# **FINAL (MYO) BASELINE MONITORING REPORT** **SIX RUNS STREAM AND WETLAND MITIGATION PROJECT**

NCDMS Project #100170  
DMS Contract #0303-01  
RFP: 16-20190303 (Issued 12/20/2019)  
USACE Action ID: SAW-2020-01964 | DWR Project #20201798 v1

RE: DMS Comments on the MY0 Report Six Runs, Project ID #100170, DMS Contract #0303-01, RFP 16-20190303

Listed below are comments provided by DMS on July 31, 2023 regarding the Six Runs Stream and Wetland Mitigation Project As-built and MY0 Baseline Monitoring Report and RES' responses.

**SHEET NUMBER:** S6

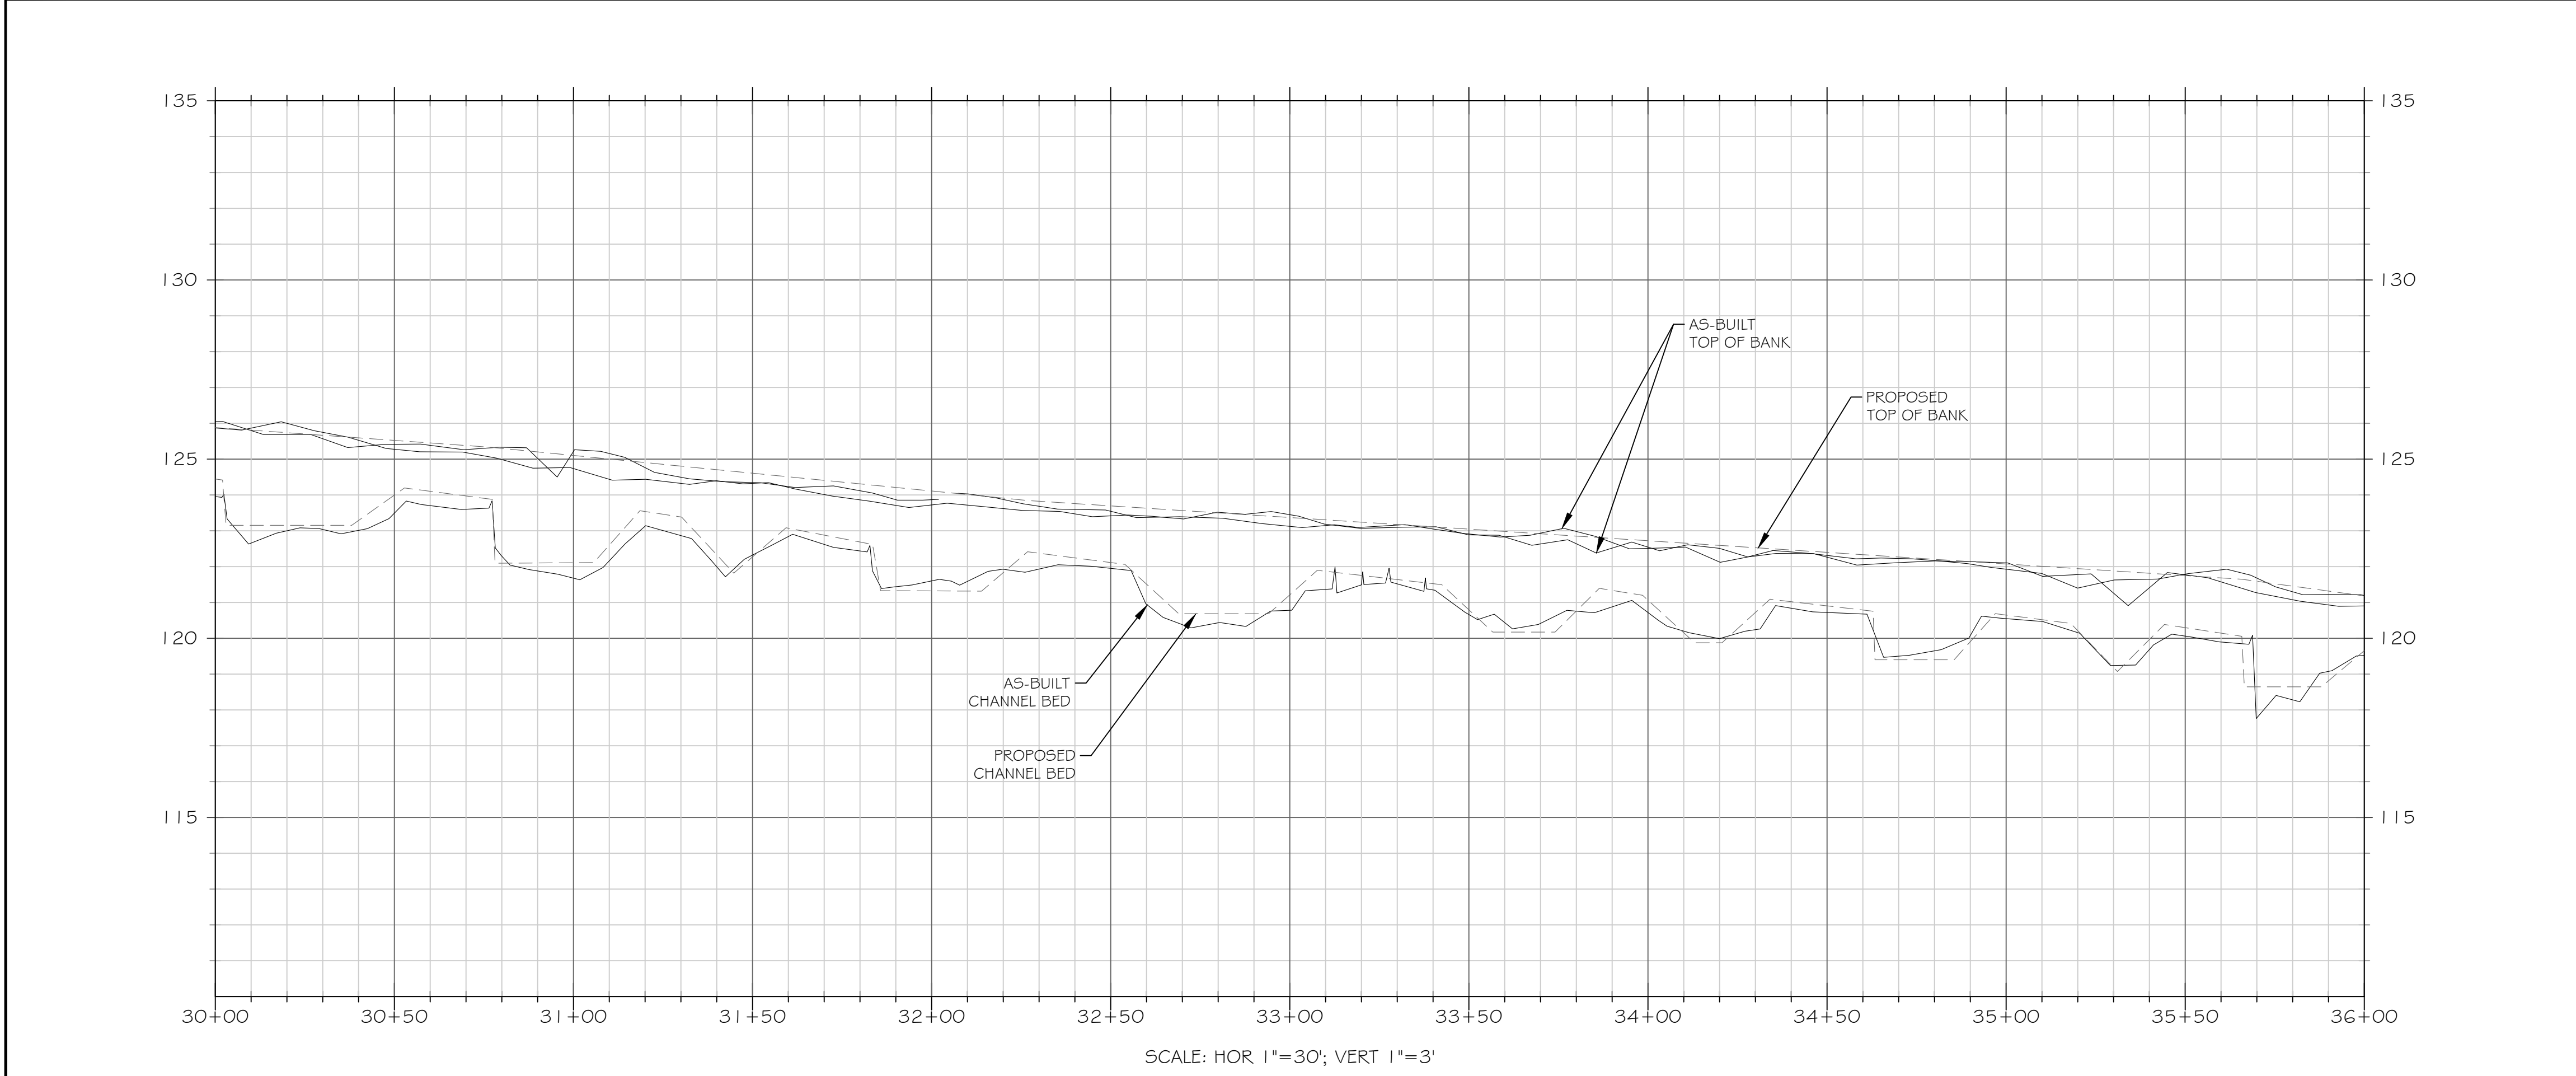
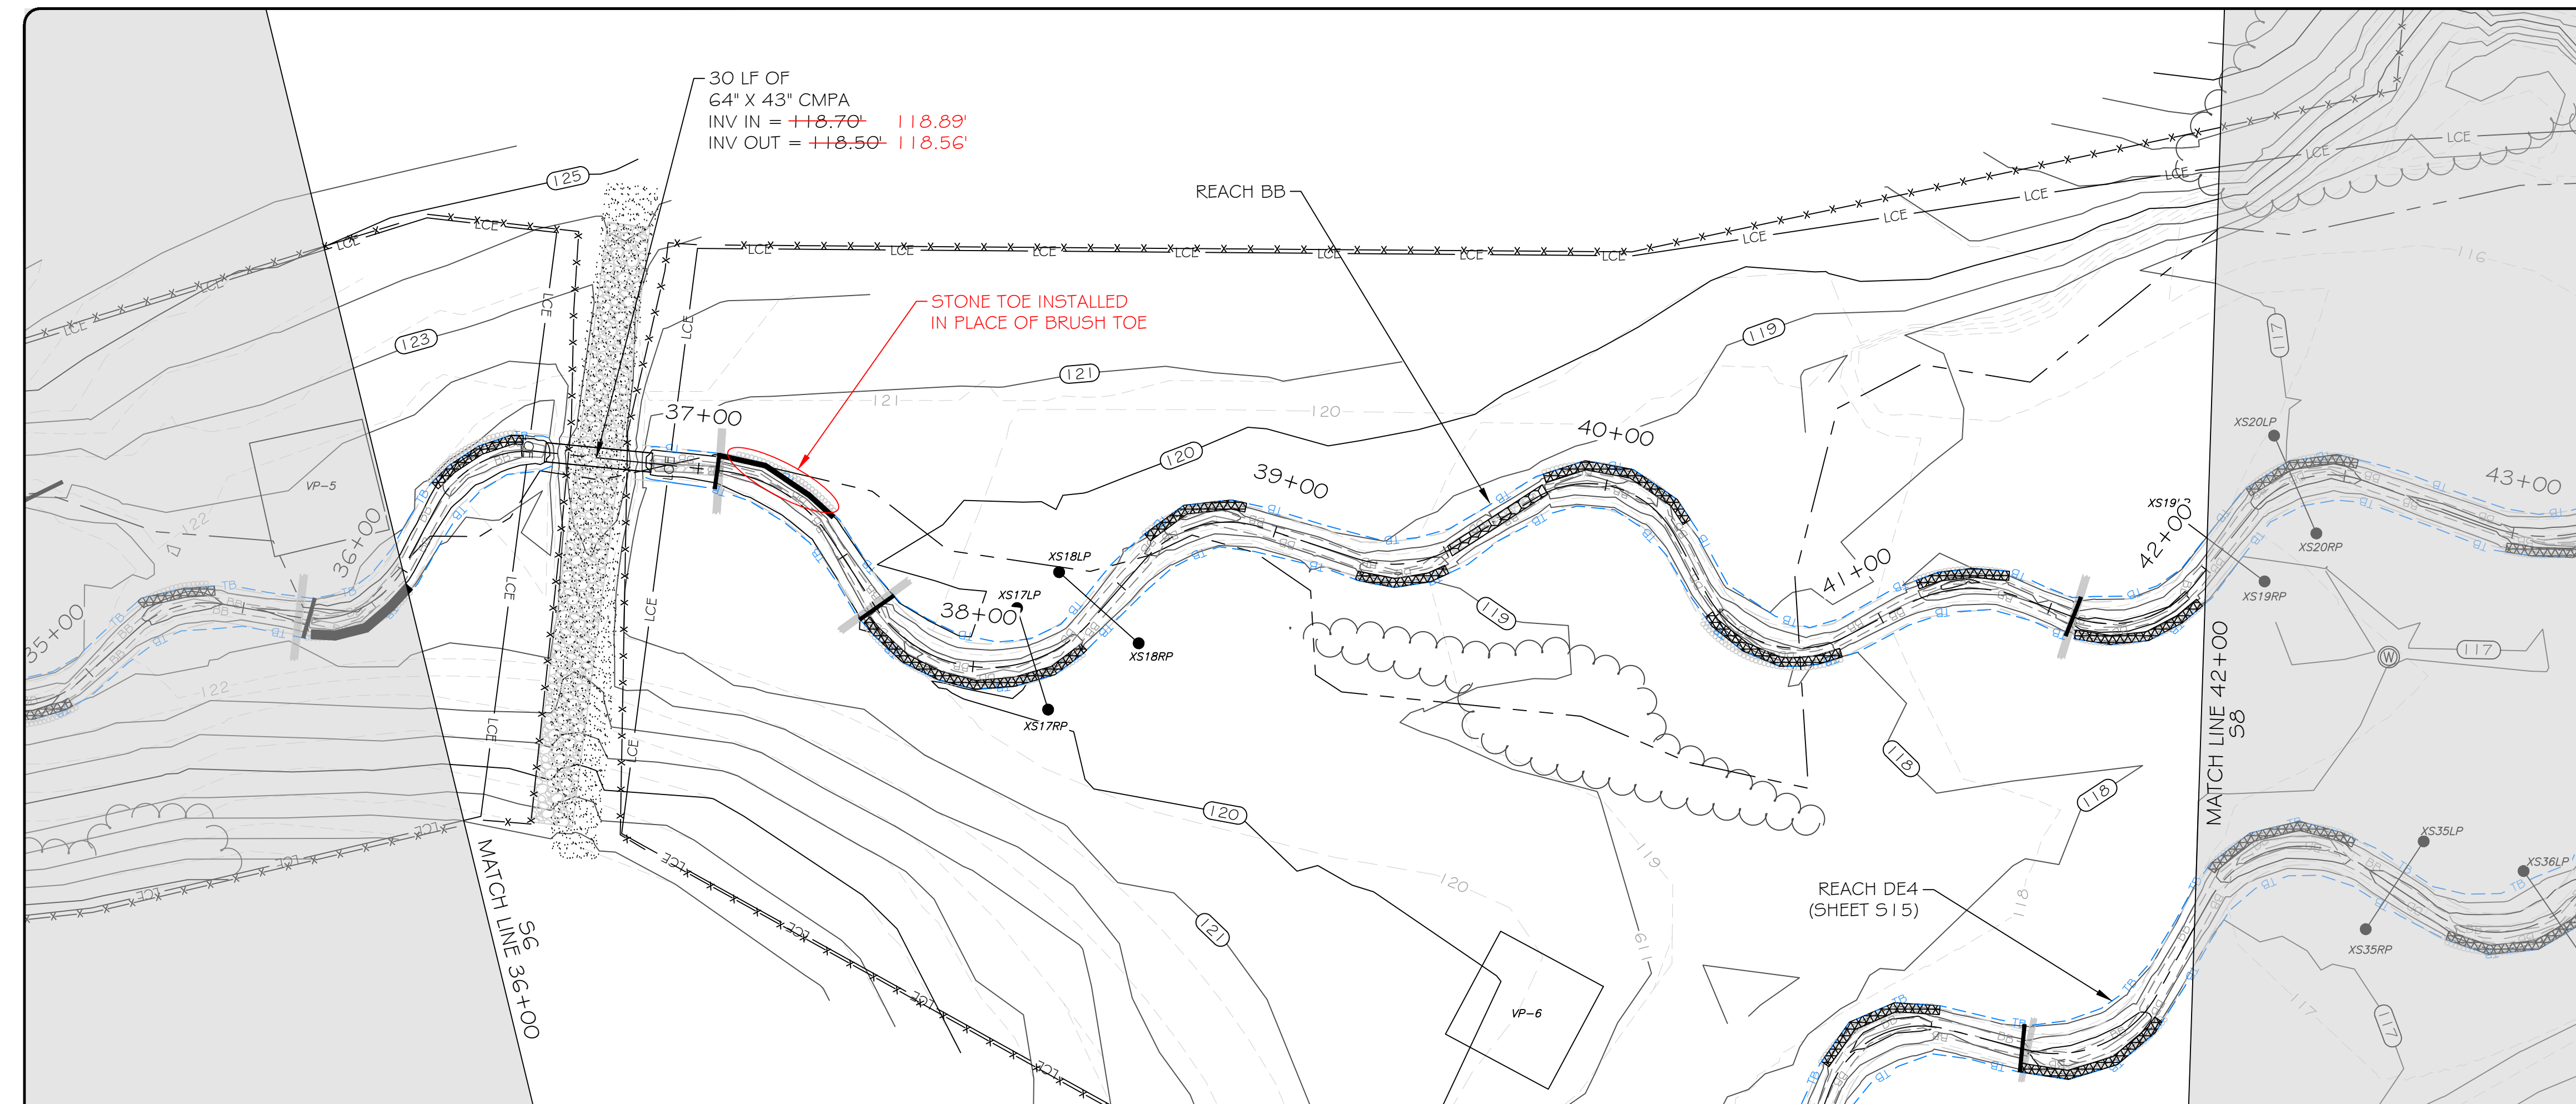
11. Sheet S6 – Log structure upstream of Sta. 35+00 was not surveyed but was found in the field. Also, log structure at Sta. 30+00 is shown as surveyed in as-built survey drawings (S7), but not the record drawings.  
Log sill upstream of Sta. 35+00 has been added along with a red callout.  
The surveyed log sill at Sta. 30+00 has been added to the record drawing sheets.
